CEMVN-CD-NO-Q

18 September 2000

SUBJECT: Contract No. DACW29-99-C-0005, Lake Pontchartrain, Louisiana and Vicinity, London Avenue Outfall Canal, Parallel Protection, Floodproofing of Gentilly Boulevard Bridge, Orleans Parish, Louisiana

PLAN

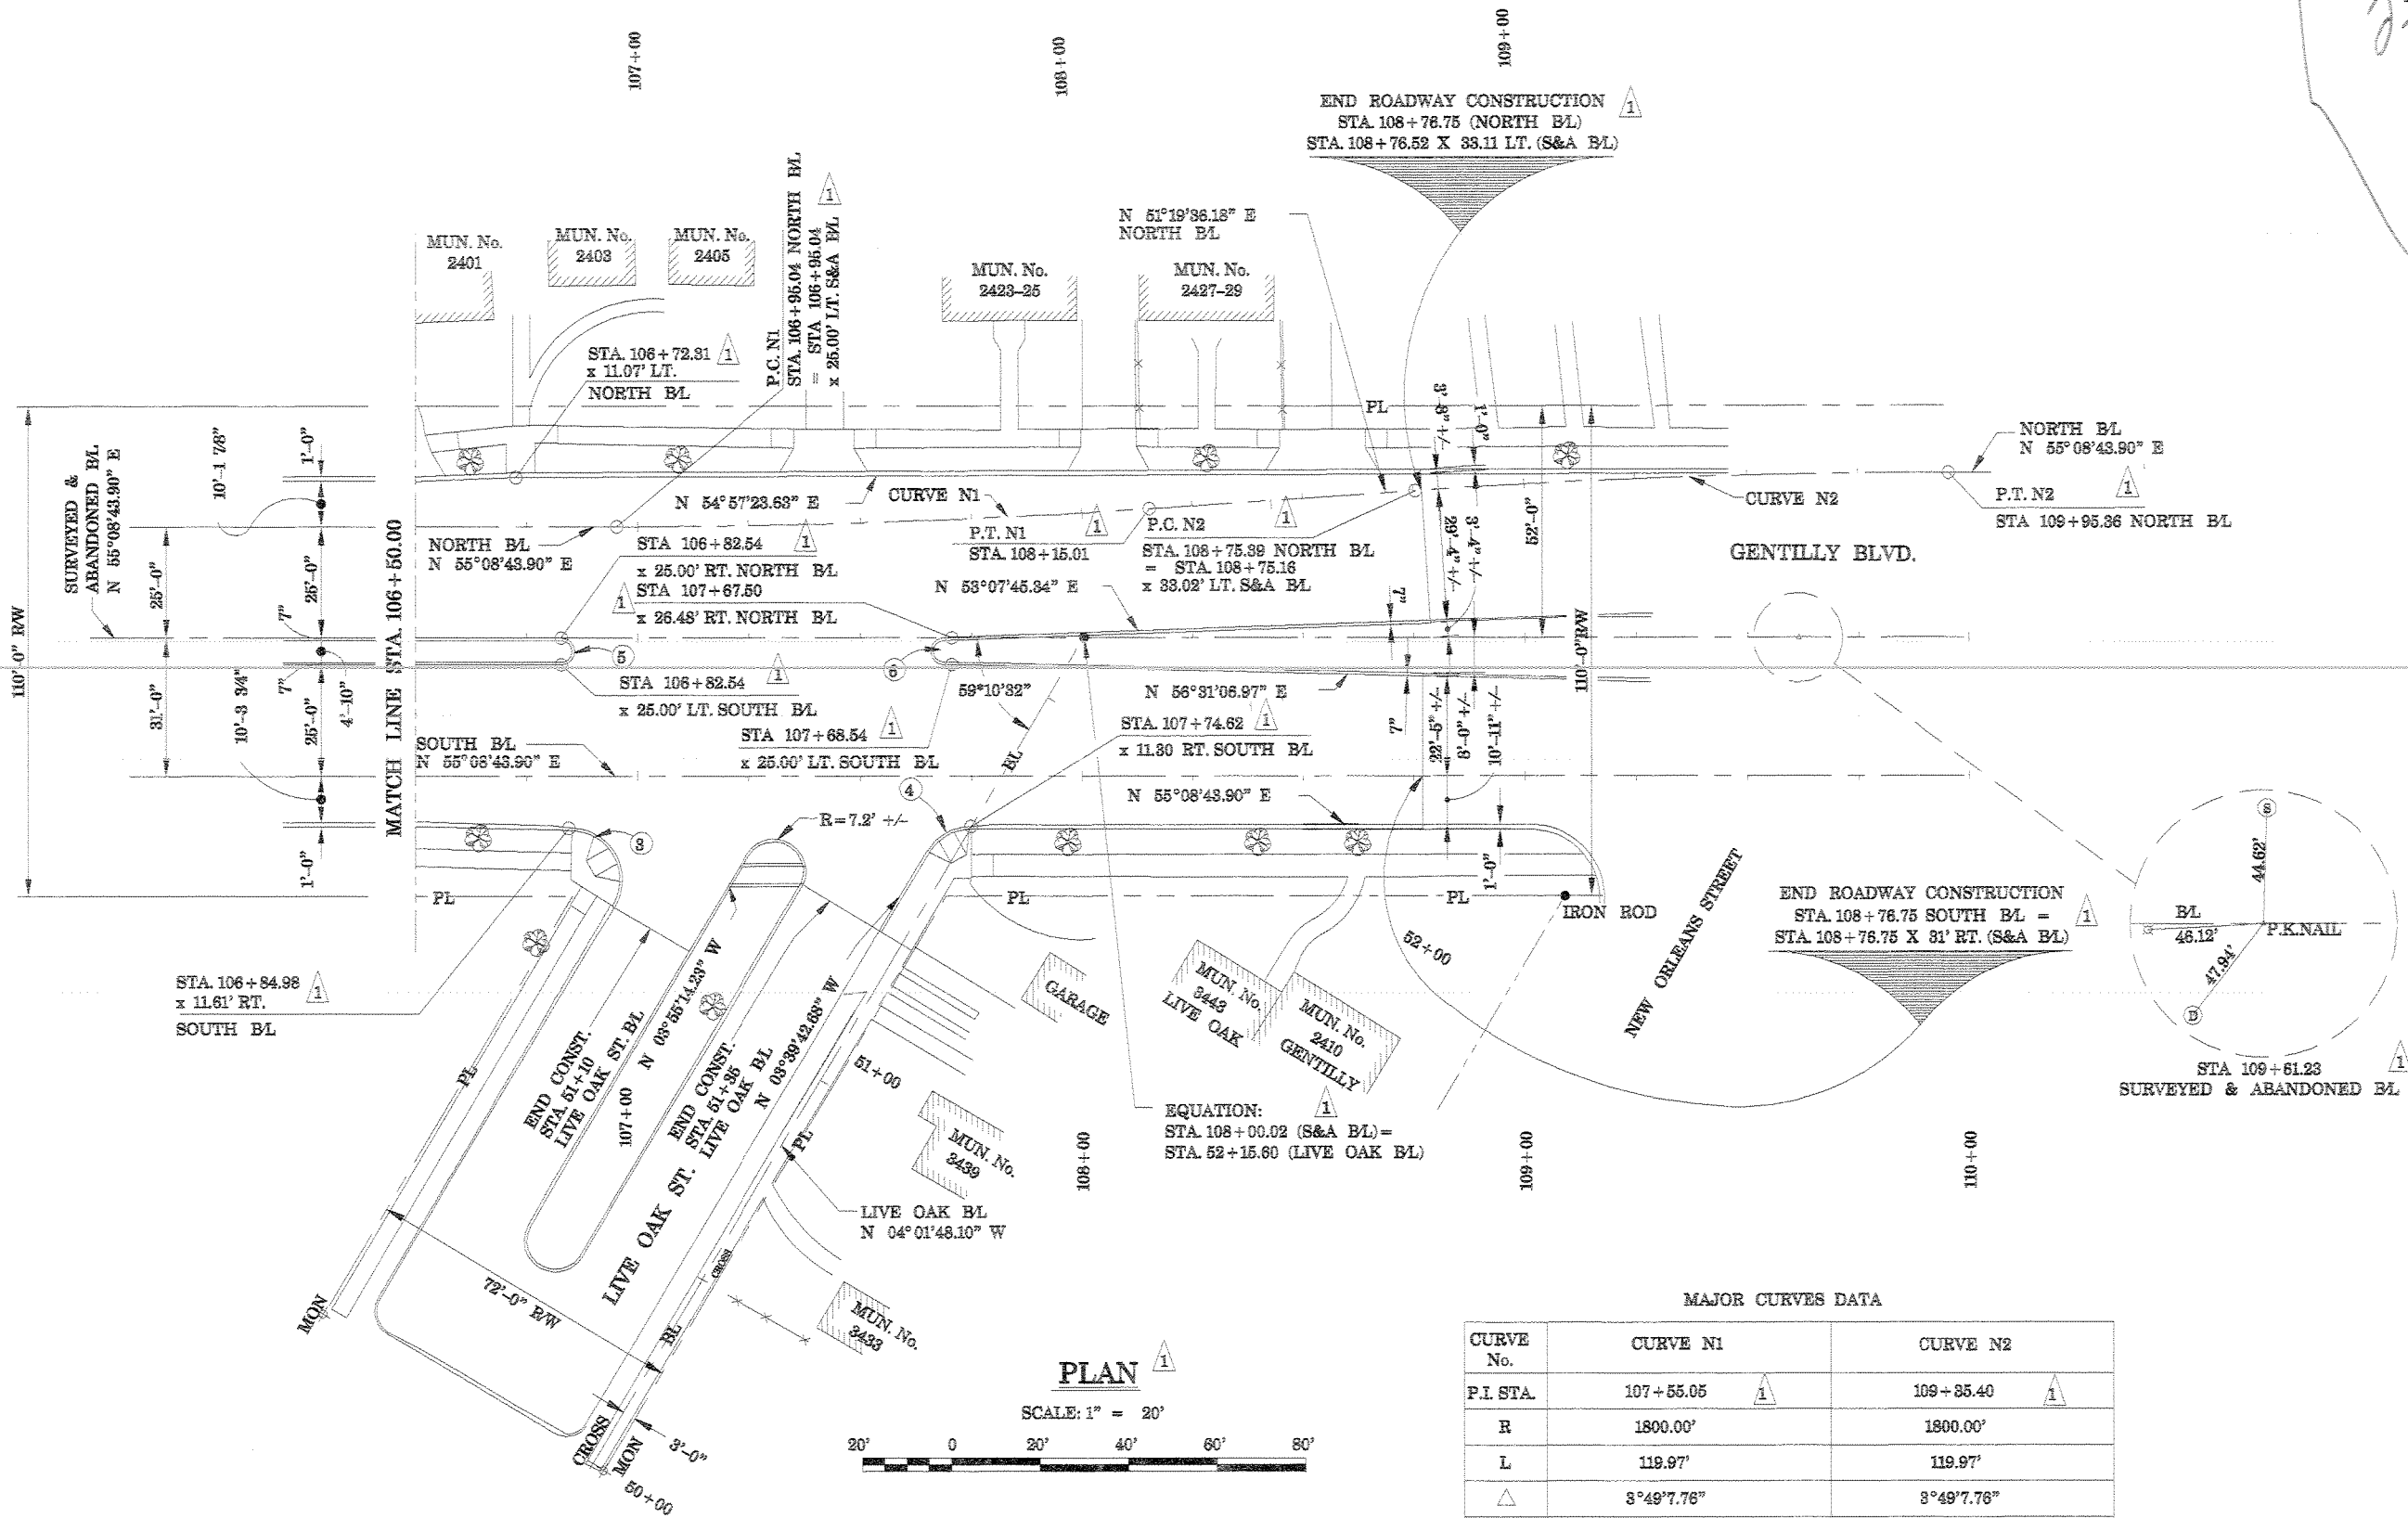
Handwritten note: (A00004) REFER TO Dwg 23-24B FOR DRAINAGE & WATERLINE CHANGES

PLAN

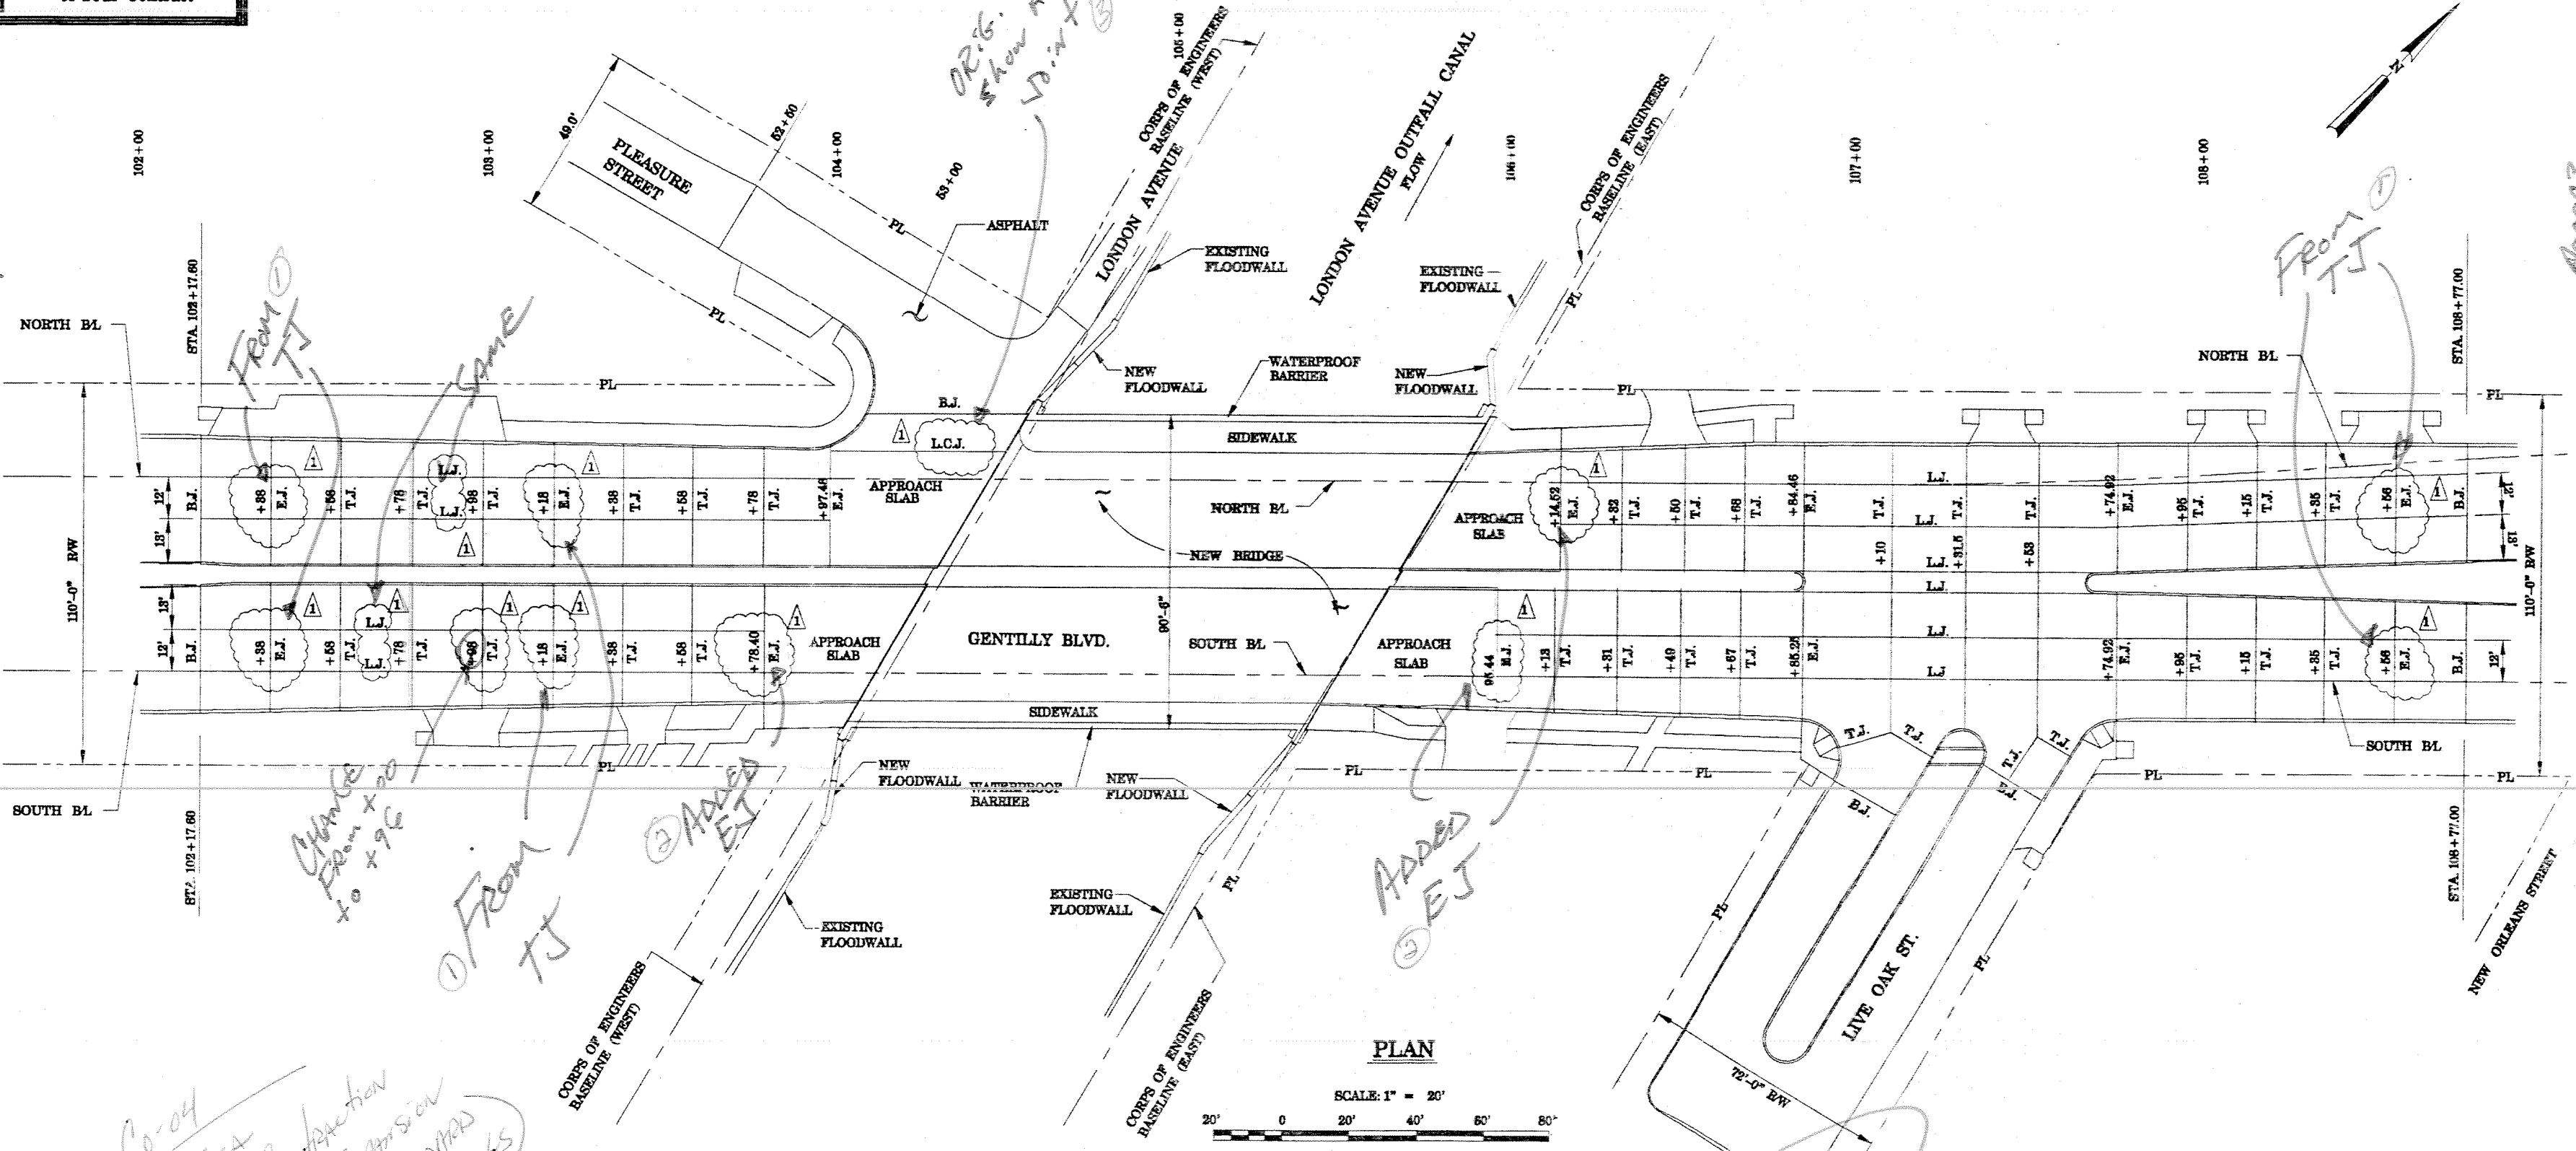
A00003

PLAN

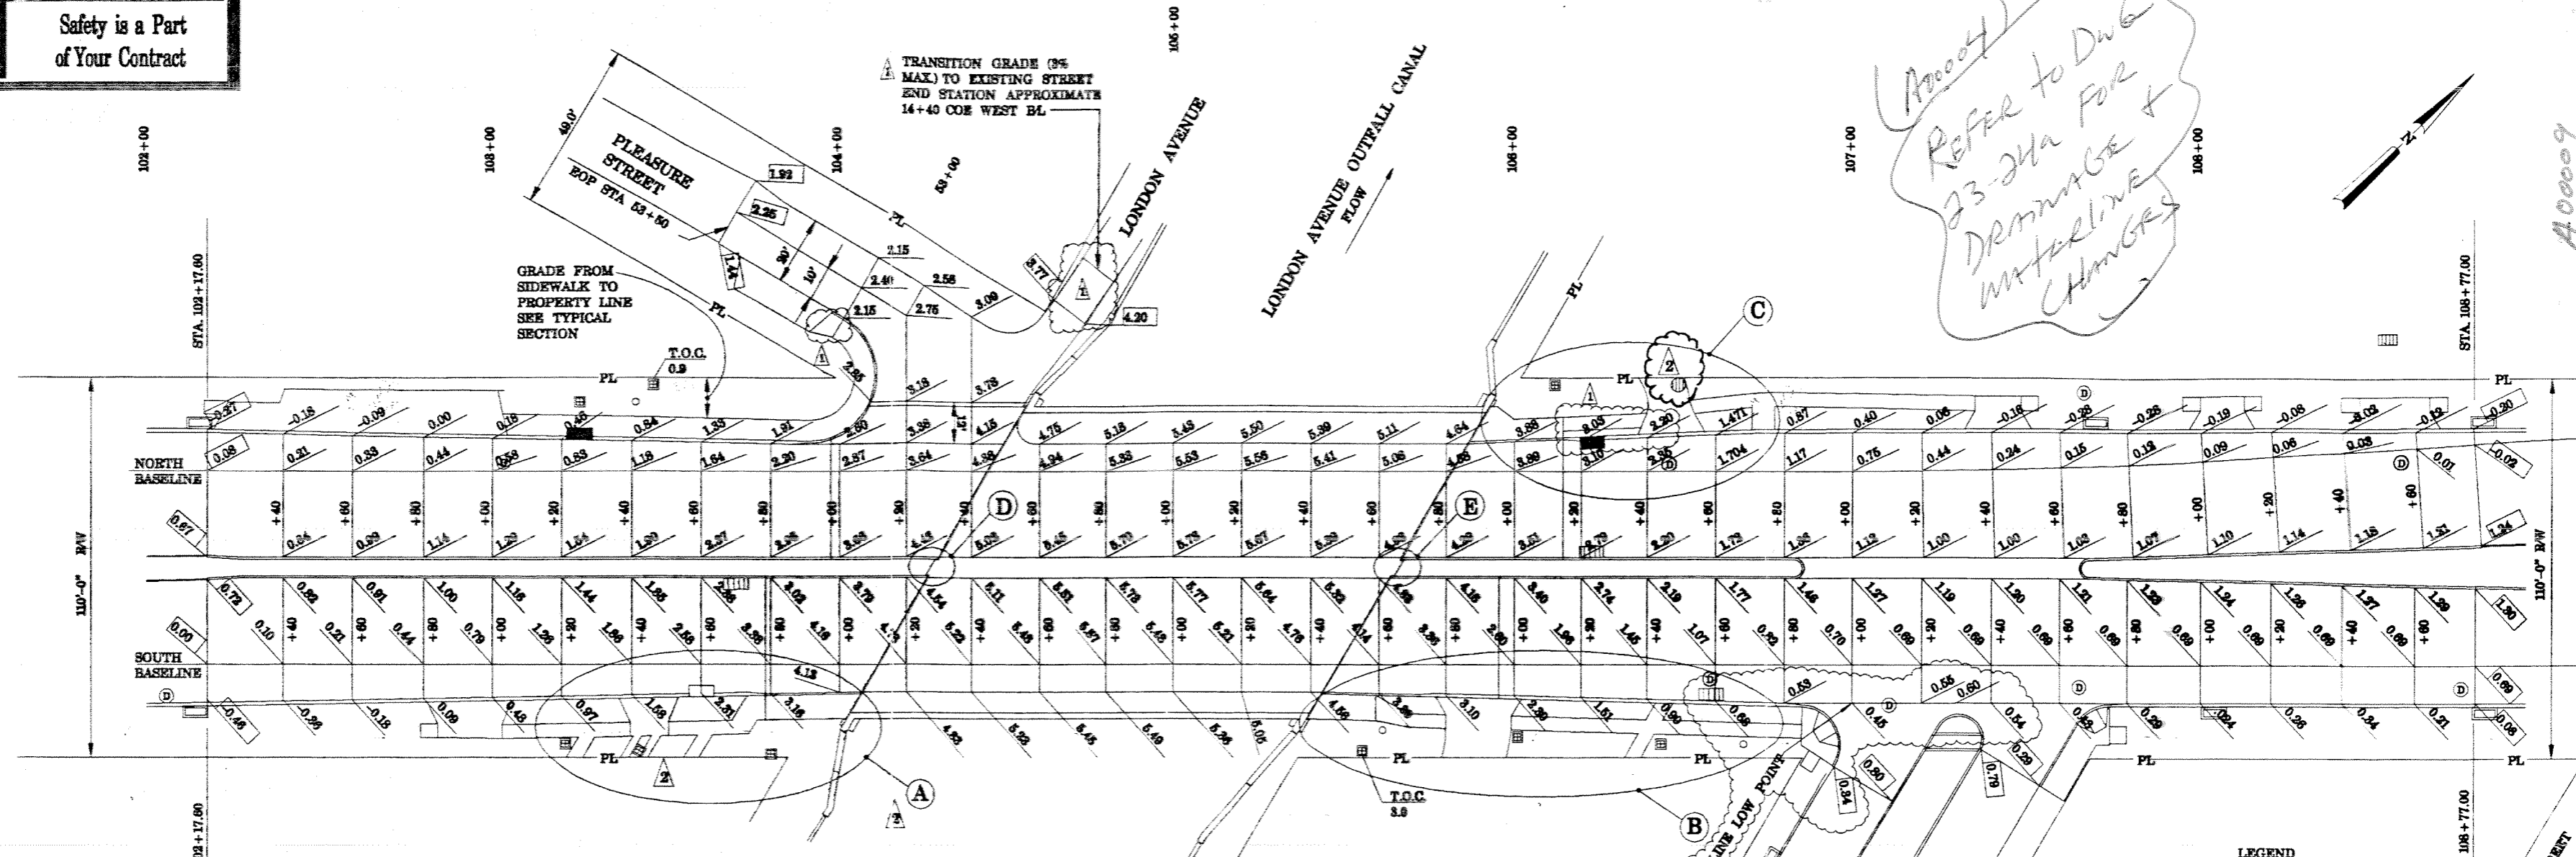
(A0004)
REFER TO DWG 23-21A FOR DRAINAGE & UTILITY CHANGES
